ADDENDUM NO. 1

Reference: Stewart Stadium Field Renovation
WSU - Ogden, Utah

Project No.10280810

Addendum No. One
for the
STEWART STADIUM FIELD RENOVATION
WEBER STATE UNIVERSITY
DFCM PROJECT NUMBER 10280810
MHTN Project No. 2010575.00

AD01-C01

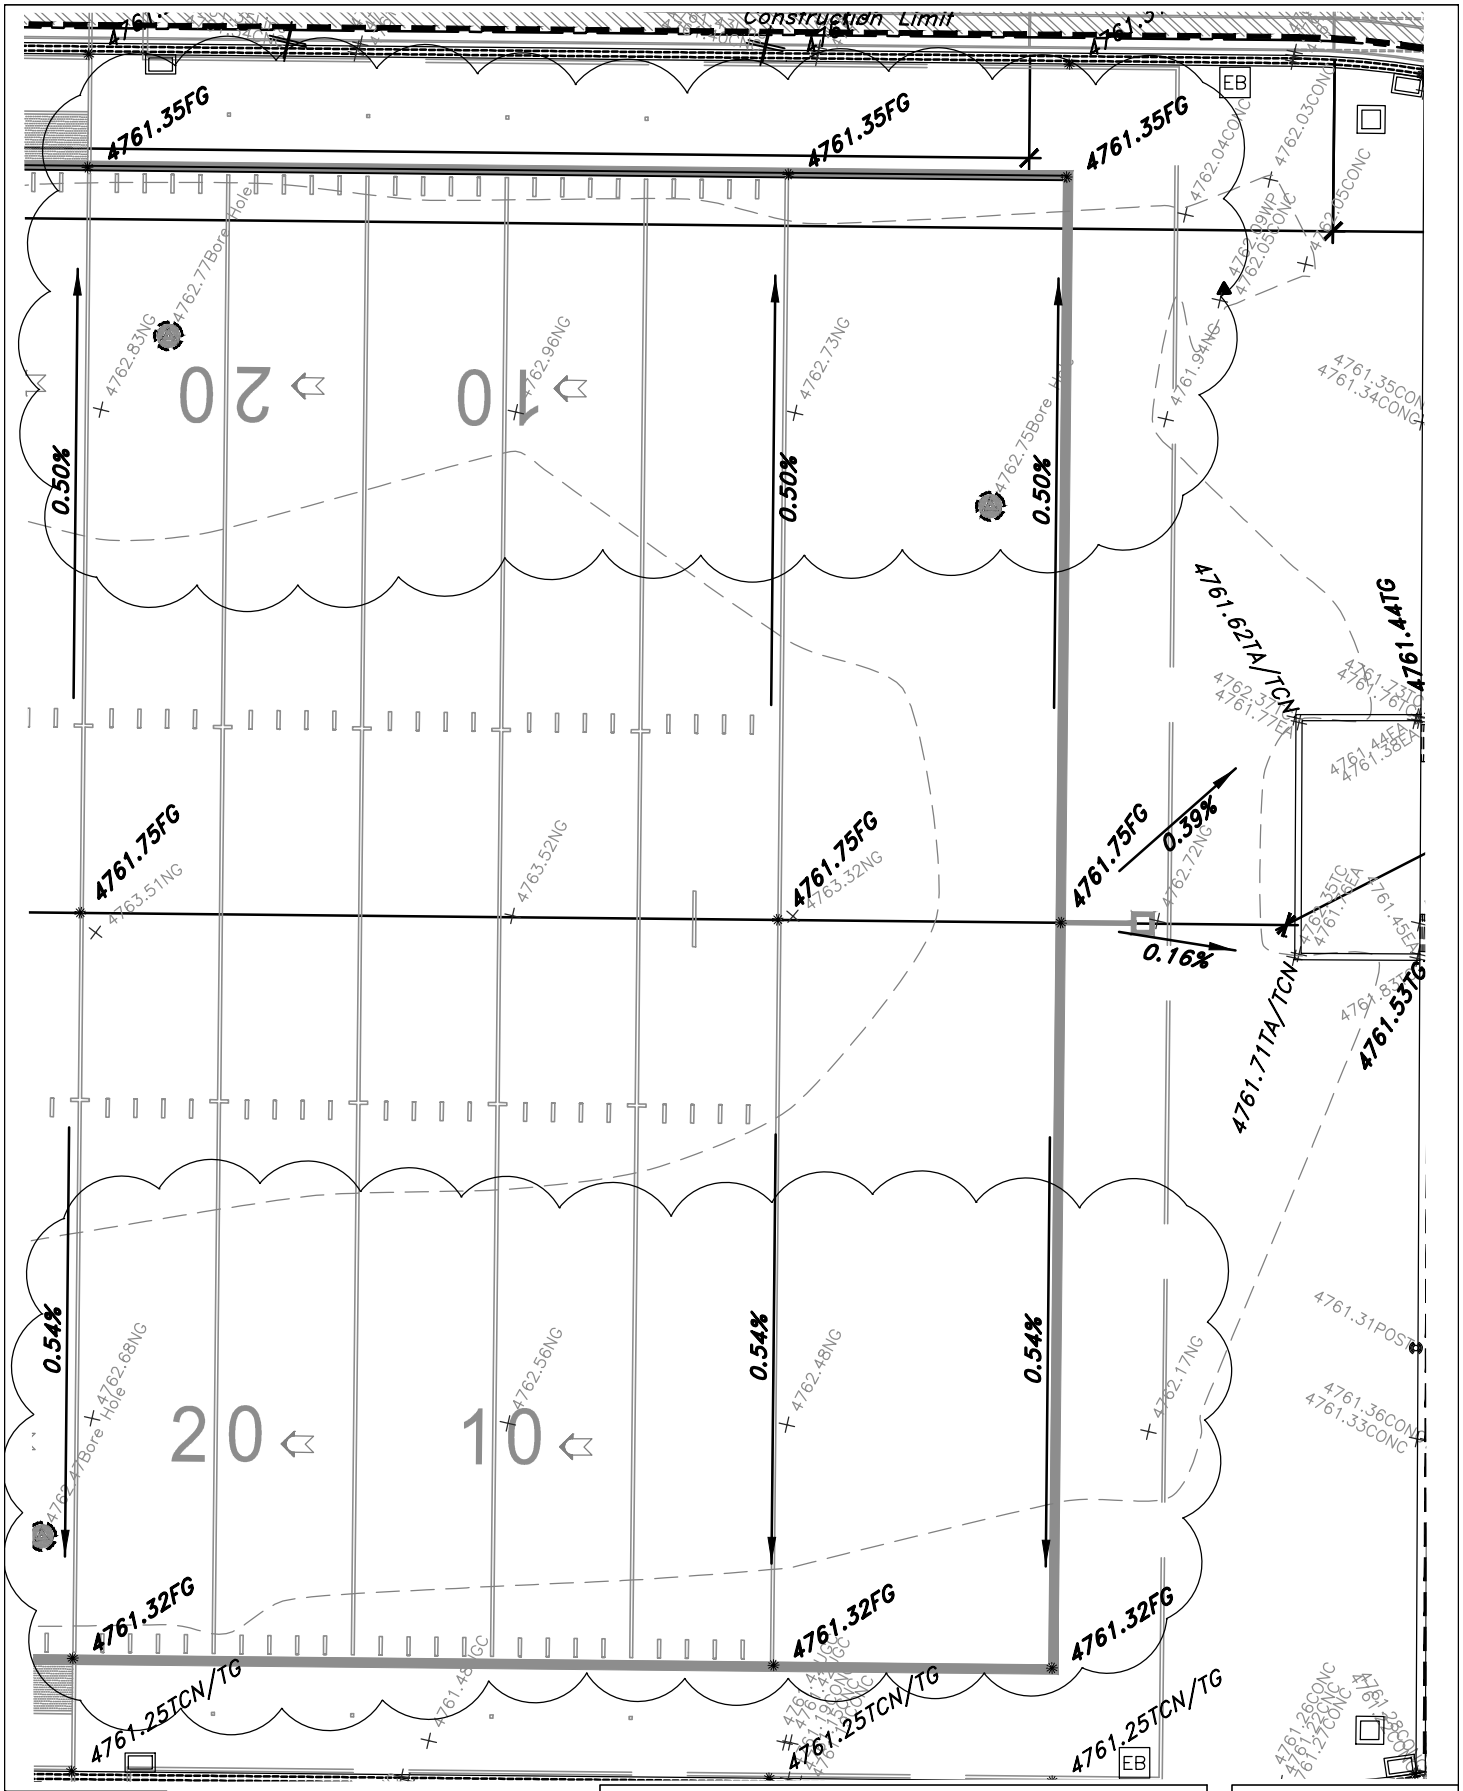
A1.6 Sheet CG101
Modify the finish grades of the football field as per AD01-CO1 thru CO3

Sheet No.
AD01-C04

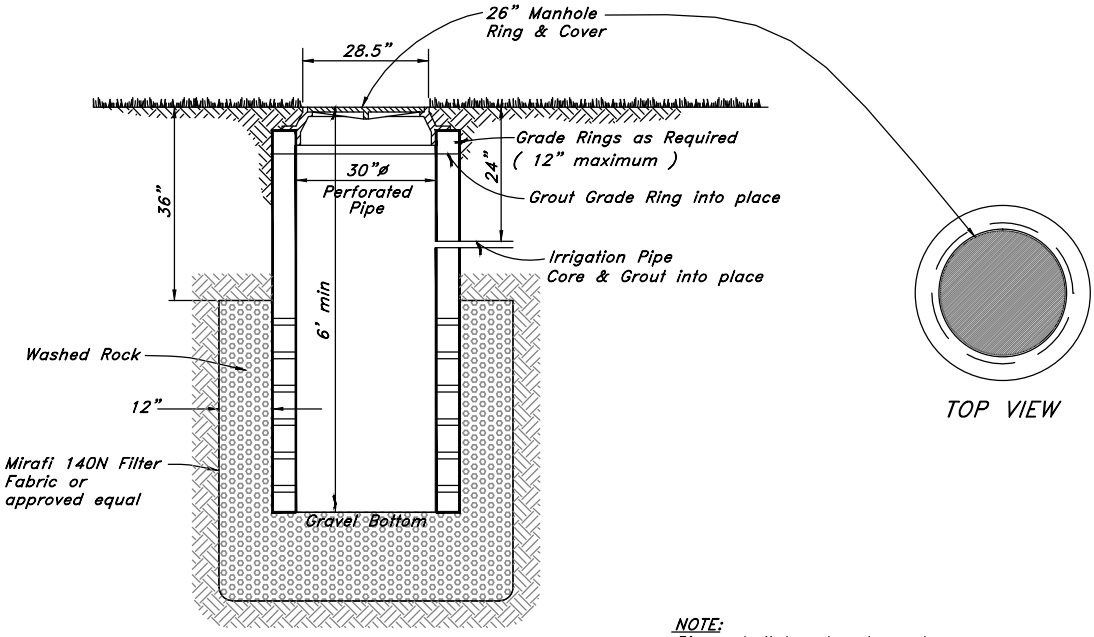
b. Provide a concrete sump in the south track event area as part of the **base bid** as per ADD1-C04.

d. Provide a concrete sump in the south track event area as part of the **Alternate #1** bid as per ADD1-C04.

AD01-C05

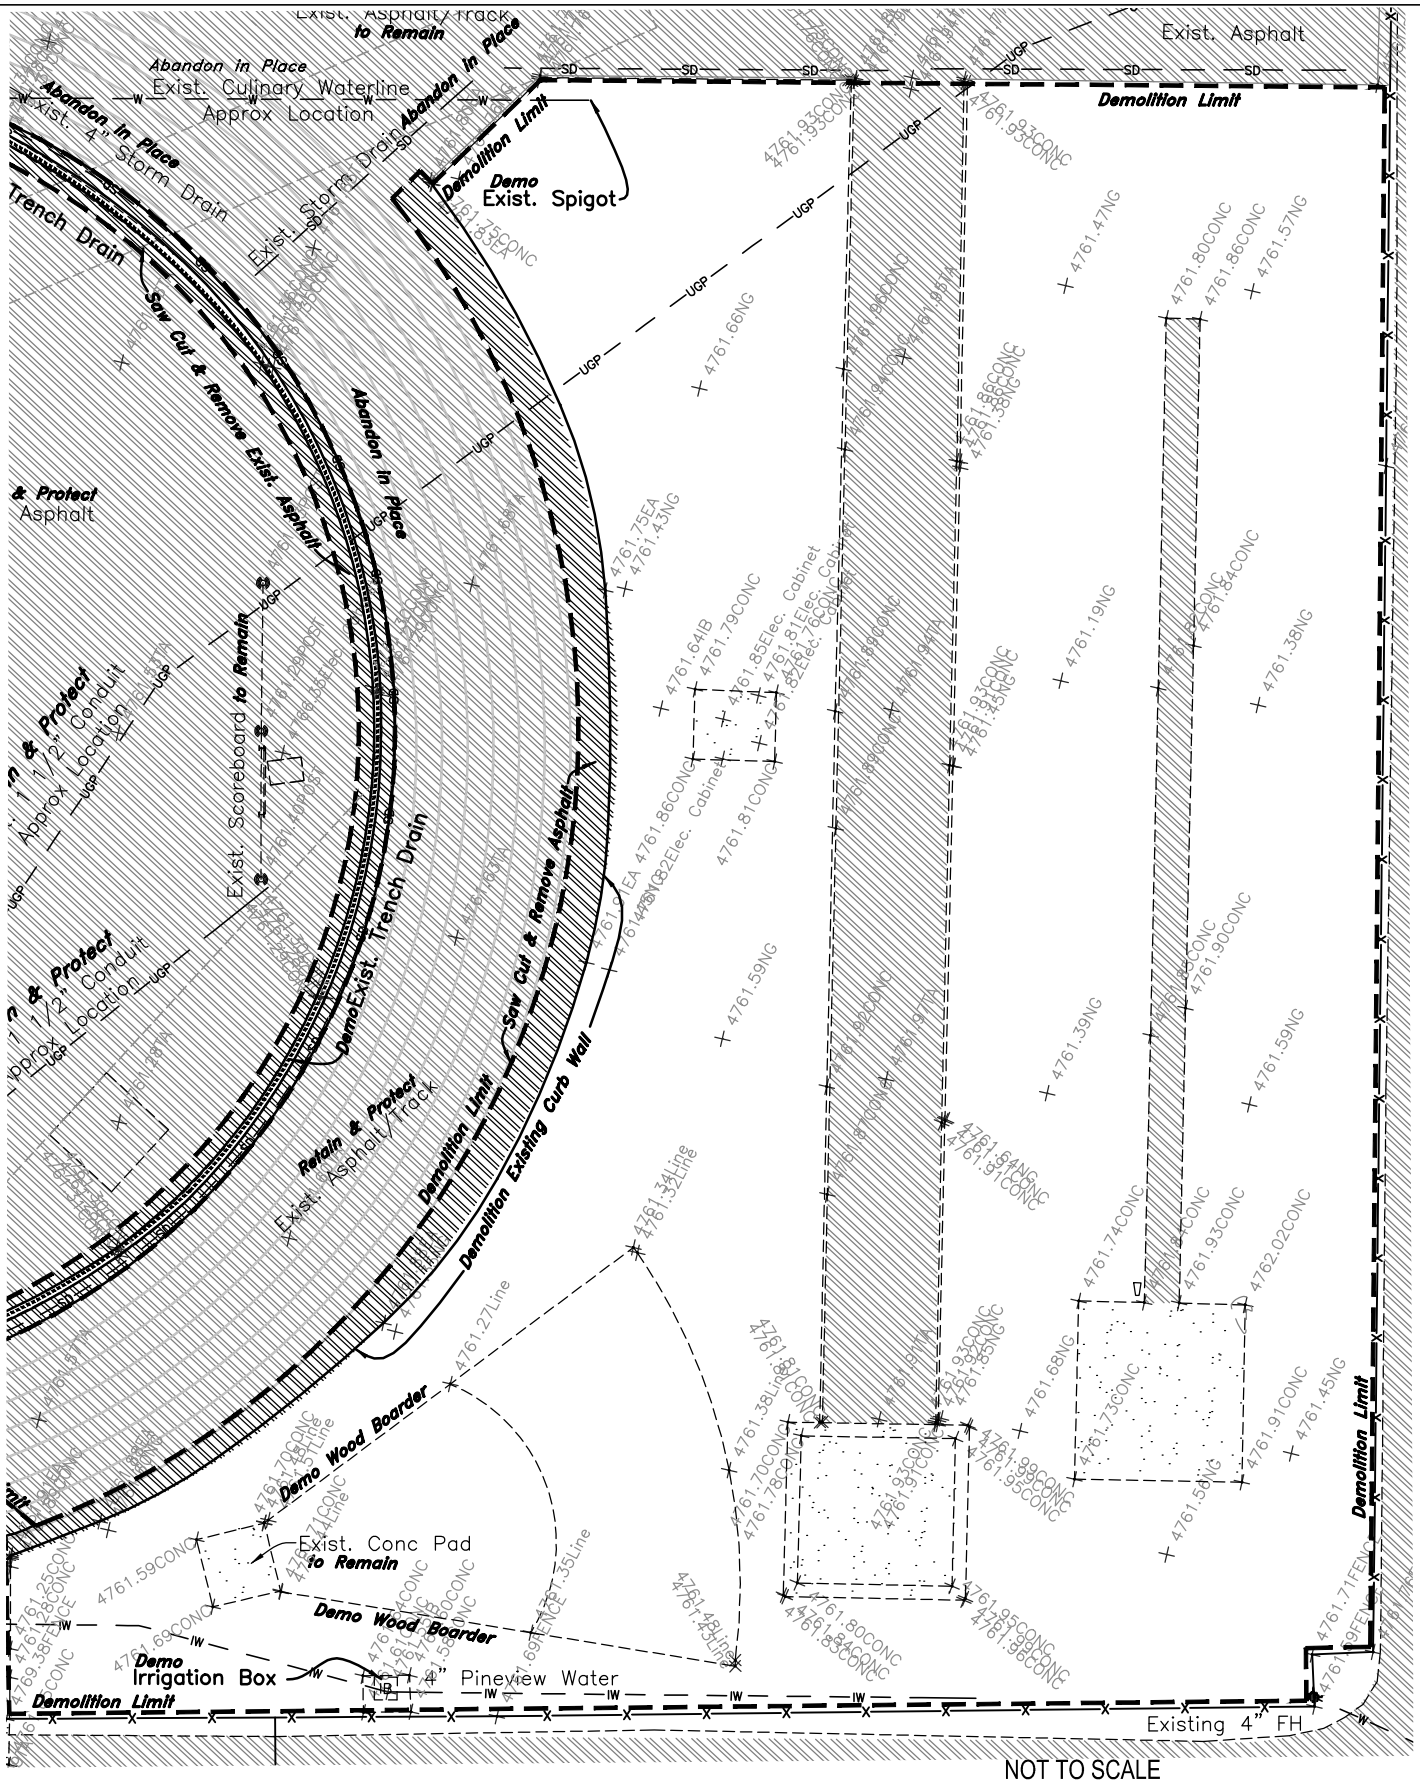
A1.4 Sheet CD102
Revise the demolition in the south track event area in the **base bid** as per AD01-C05
The **Alternate #1** demolition requirements in the south track event area are shown on the original drawing and as per AD01-C06.

AD01-C07

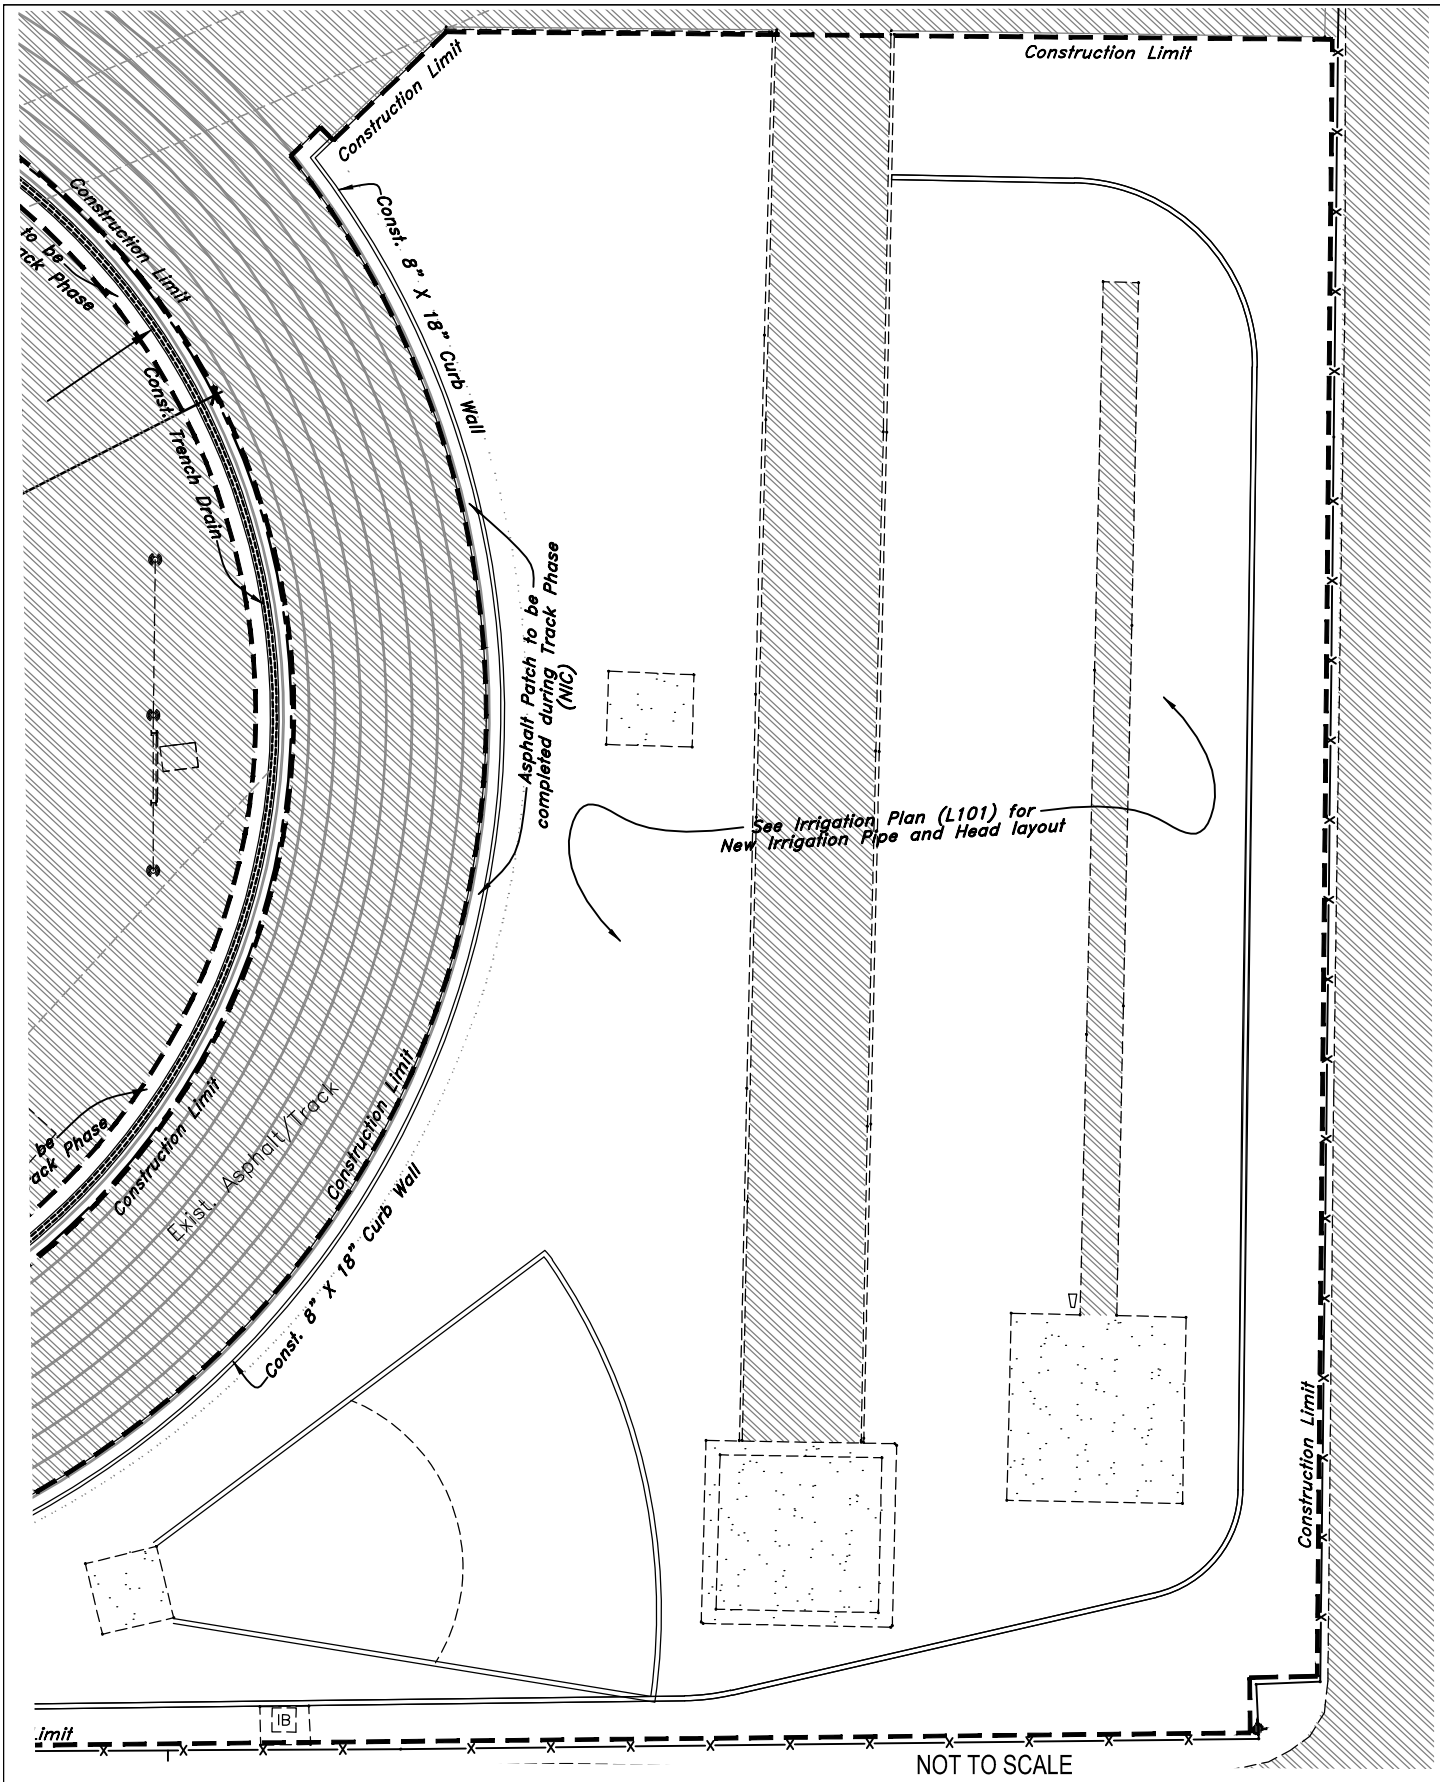
A1.5 Sheet CS102
Revise the construction requirements in the south track event area in the **base bid** as per AD01-C07
The **Alternate #1** construction requirements in the south track event area are shown on the original drawing and as per AD01-C08.

AD01-L01

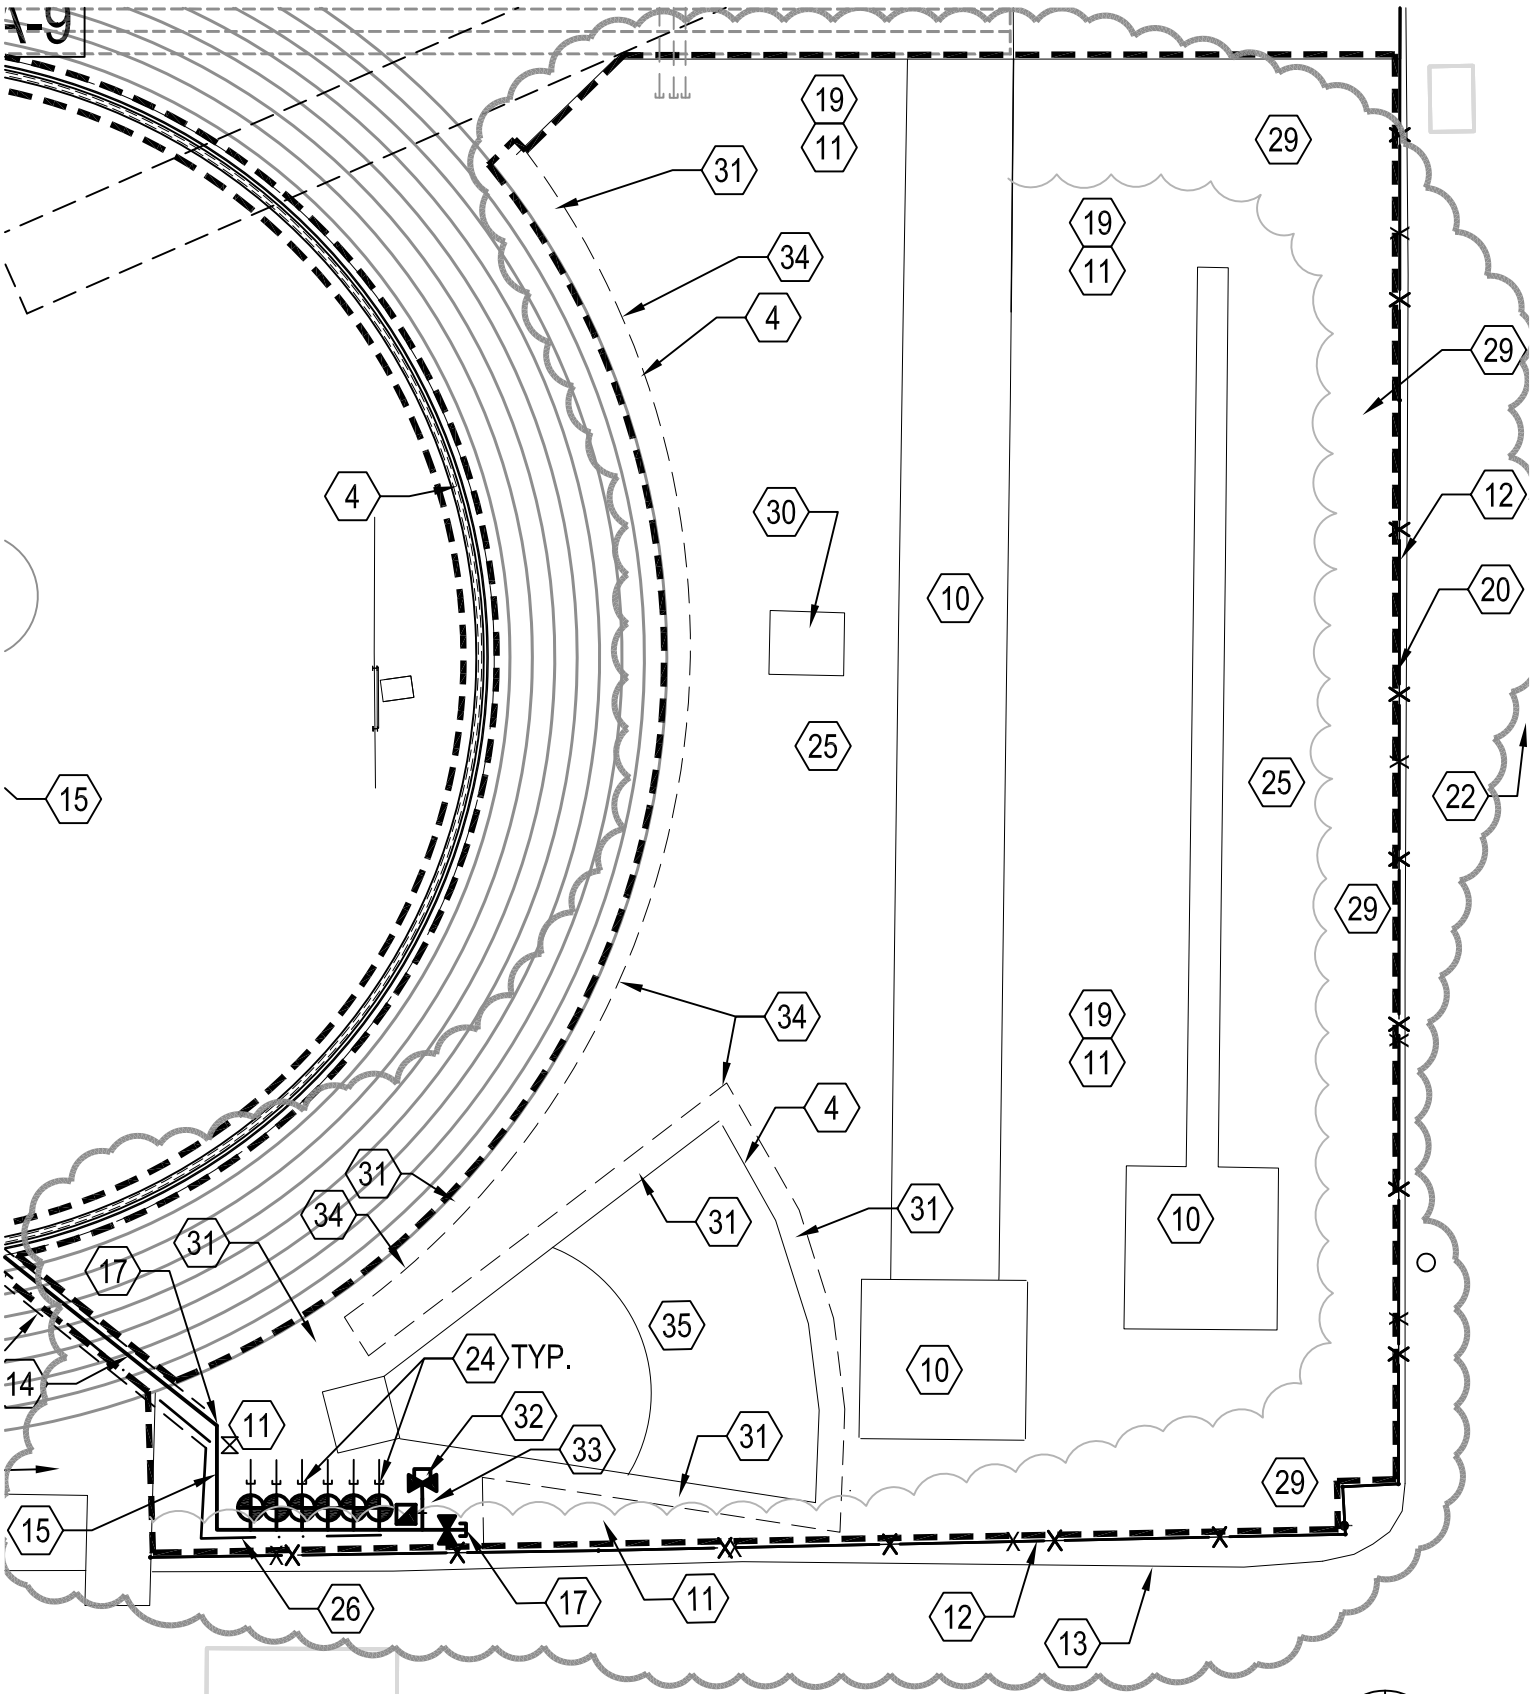
a. The **base bid** construction in the south track event area shall consist of sod repair due to installation of new concrete curb and revisions to the irrigation system as shown on AD01-L01.
